**SUBJECT:** Snyder Hall Structural and Exterior Improvements  
Contractor: J. L. Tripp Builders  
Contract No: 9586-09

Forwarded herewith for execution is Change Order No. 2 for subject project.

Change Order No. Two (2) Date March 18, 2015

Description of Project Snyder Hall Structural and Exterior Improvements

## ATLAS RESISTANCE® STANDARD AND MODIFIED 2-PIECE SYSTEMS

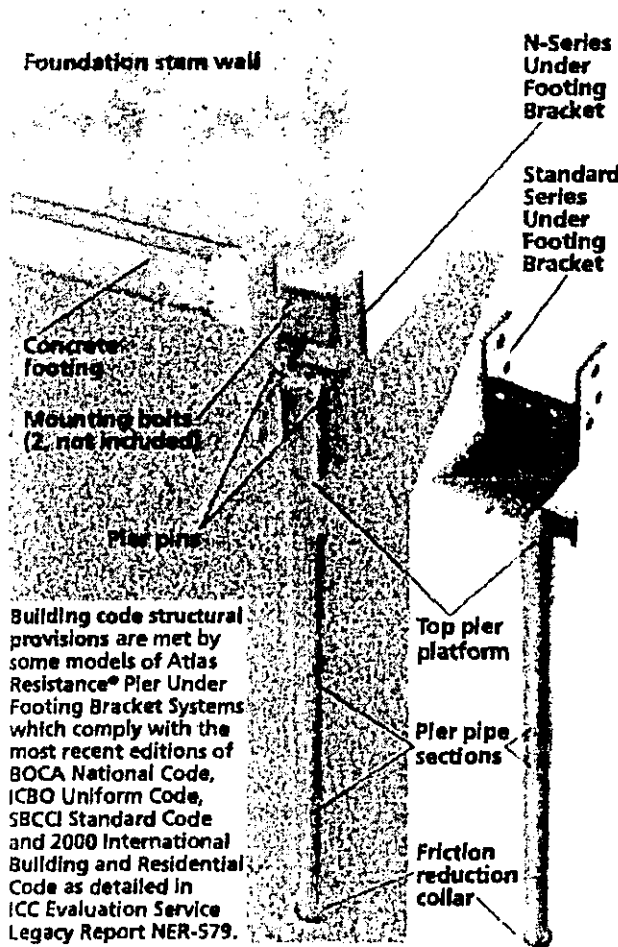
1. Use minimum 3-1/2" diameter piles per general notes.

use min 3-1/2" diameter piles per gen. notes

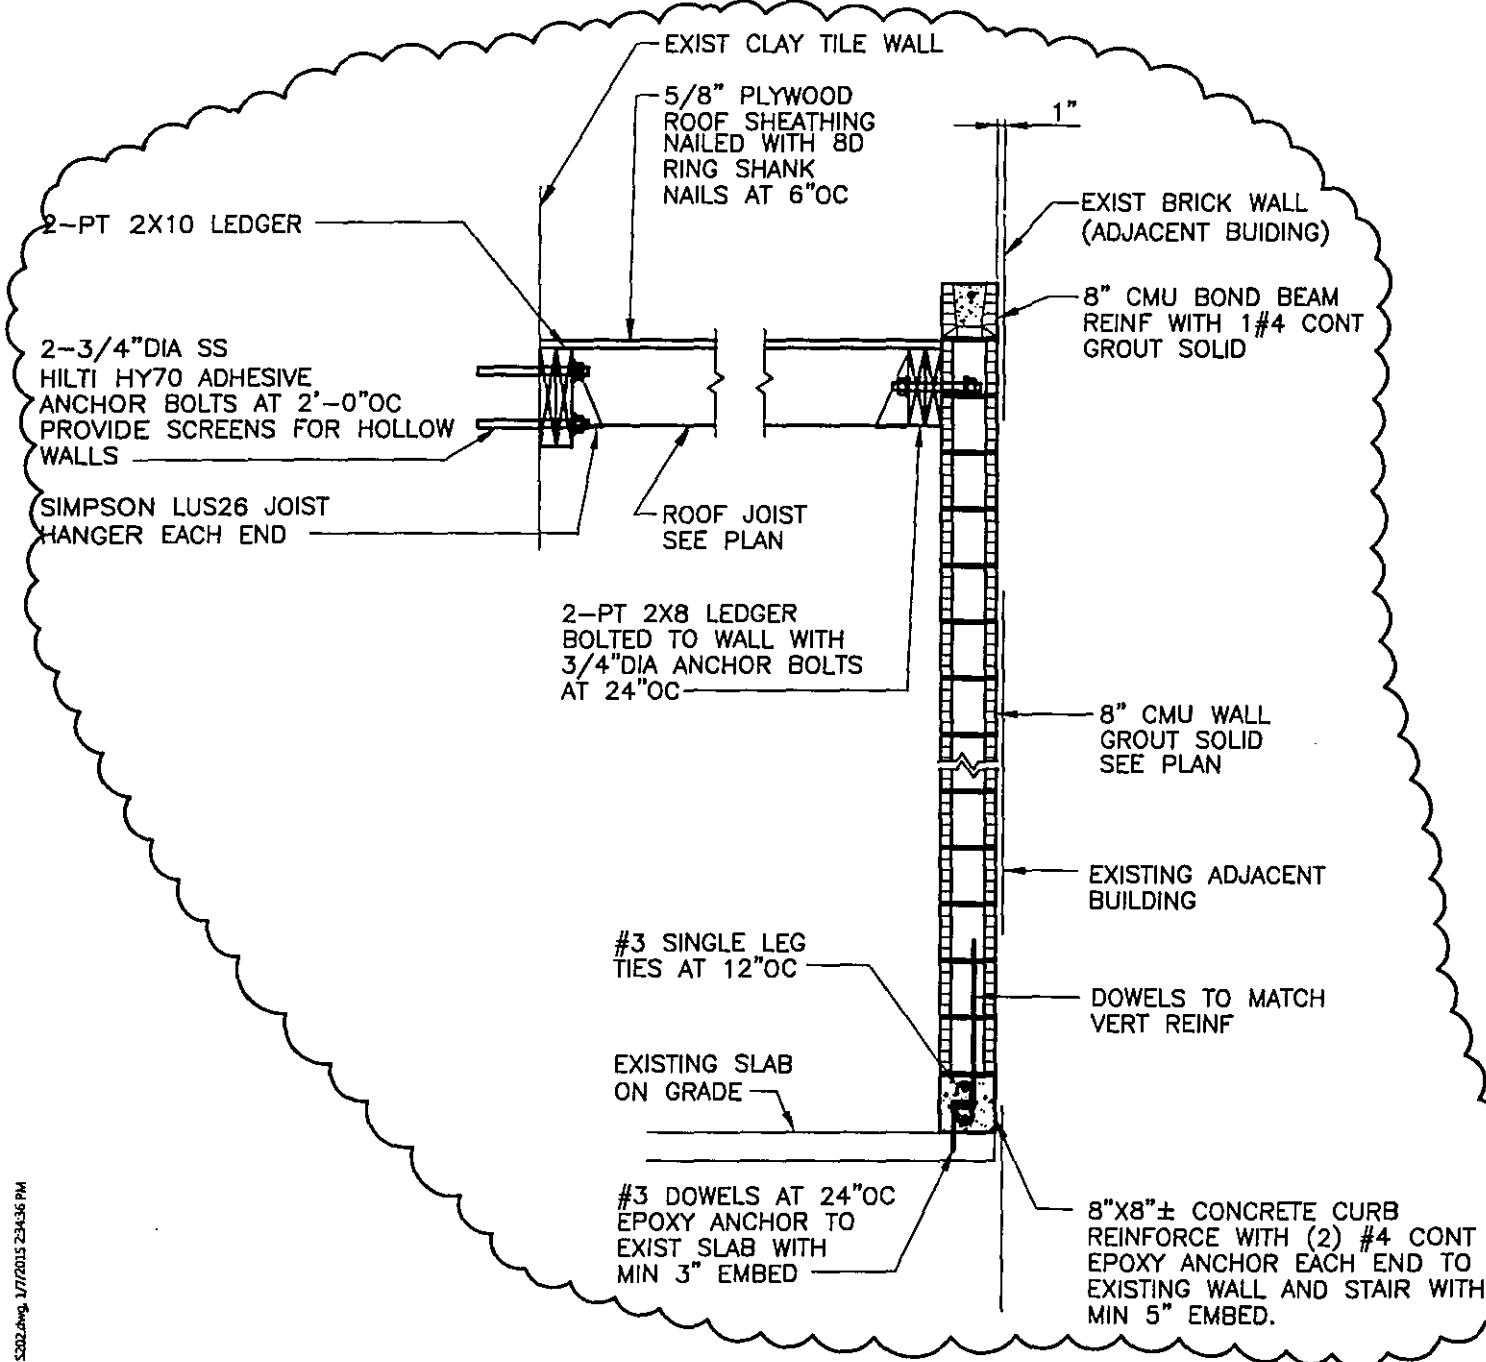
- To provide new wall as per drawing provide by Atlantic Engineering Services, as per sketch dated 1/21/15, worksheet # S-202, sketch number SK-11 and to fill all cells solid as per Kem at VRL Architects
-Demo of existitng exterior restroom walls down to 12" bearing wall in order to re-lay block
-Additional Labor costs-16 hrs @ \$170/hr-\$2,720.00
-Foreman @ \$50/hr, 6 laborers @ \$20/hr
-Dump fees-\$500.00
-Block wall to include footer-\$10,500.00
-price is to include blocks, sand, mortar, concrete, rebar, epoxy and labor to complete job
-Fill cells-this will be done in five (5) lifts filling all cells solid
-Additional Labor costs-40 hrs @ \$170/hr-\$6,800.00
-Foreman @ \$50/hr, 6 laborers @ \$20/hr
-Material cost (concrete)-\$2461.00
-Permitting-\$750.00
